SERVICE BULLETIN

Bulletin No.....: TS-S106

**Bulletin Name.....: Replacement of steering gear box-
chassis connection bolts**

Vehicle Model.....: TS 35

Figure-1A

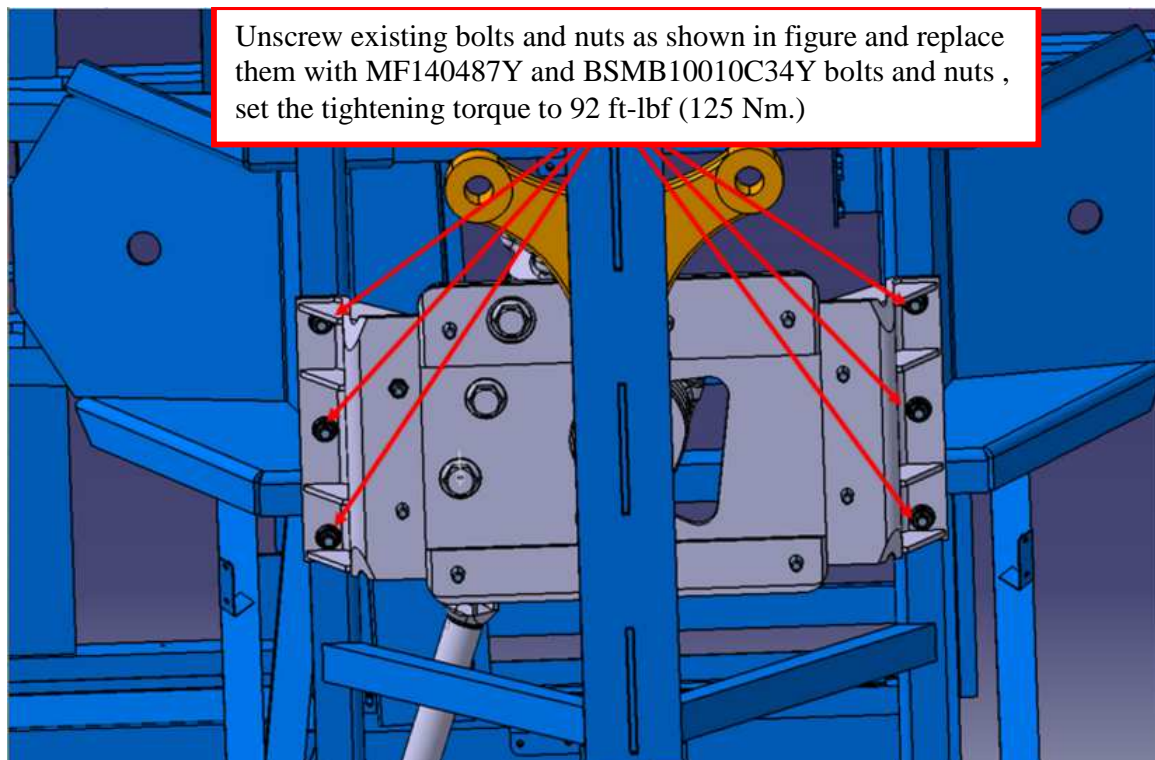
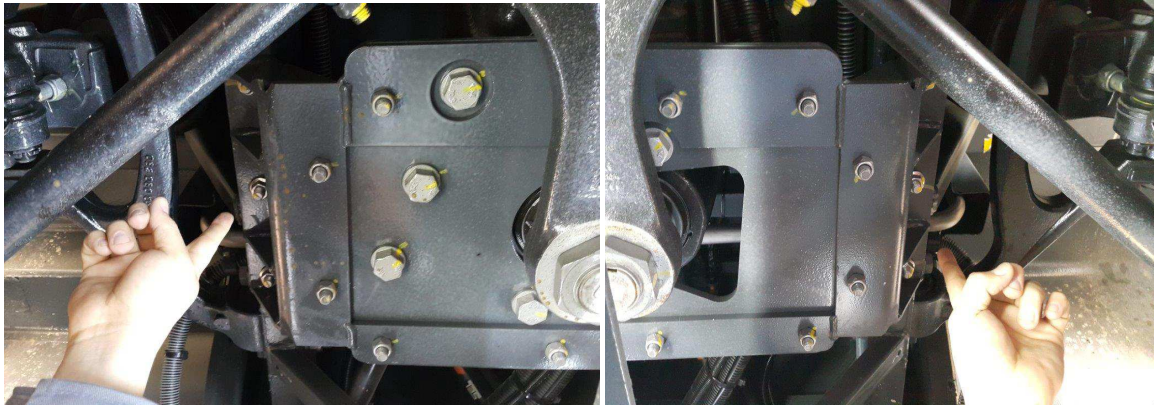
When you look at front axle area steering gear box from beneath the vehicle , unscrew MF101314Y and TF445282Y the bolts and nuts which have been used for connecting steering gear box plate to chassis as shown in figure (bottom view) one by one, replace them with MF140487Y and BSMB10010C34Y bolts and nuts , set the tightening torque to 92 ft-lbf (125 Nm) , complete the assembling.

No	Part No	Part Name	Qty	Unit Of Measure
1	BSMB10010C34Y	NUT,FLANGED,SERRATED,SAFE,M12x1,25-10K	6	Piece
2	MF140487Y	BOLT, WITH FLANGE (M12X1,25X35) K:10.9	6	Piece

- 1) Taking the vehicle, to the port or lift.
- 2) Locating the position of the bolts and nuts.
- 3) Replacing of the old bolts and nuts with the new ones.
- 4) Setting the tightening torque of new bolts and nuts to 92 ft-lbf (125 Nm).
